Med hjemmel i lov om luftfart av 15. desember 1941 § 2, ledd og § 214, fpt. ret. av 8. desember 1941 § 1 og 5, i ferdselsdepartementets pres. direkt. 20. juni 1956 og 14. januar 1957, fastsettes luftfartstilsynets forskrifter for teknisk service.

1/53 HARTZELL PROPELL MODELL HC-12 x 20

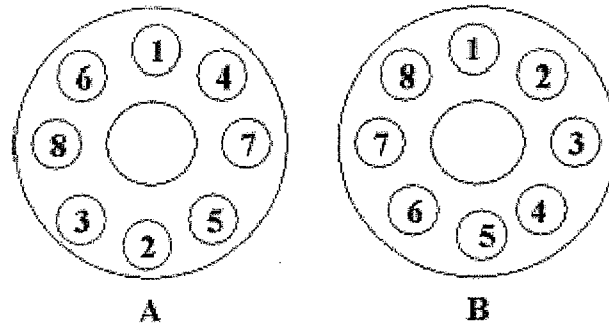
To preclude propeller attaching bolt failures or improperly secured propellers, which could lead to separation of the propeller from the airplane, do the following:

(a) Install all new propellers and serviceable propellers, as follows, before further flight:

(1) Install the propeller oil seal to the engine flange after ensuring that the engine and propeller flanges are clean.

(2) Carefully install propeller on the engine flange ensuring that complete and true contact is established.

(3) Apply MIL-T-83483 Petrolated Graphite, or Hartzell Lubricant part number (P/N) A-3338, to threads of the eight P/N B-3339 attaching bolts (and remainder of bolt if desired) and to flat surfaces of the eight P/N A-2048-2 washers, or to other equivalent FAA-approved serviceable bolts and washers.
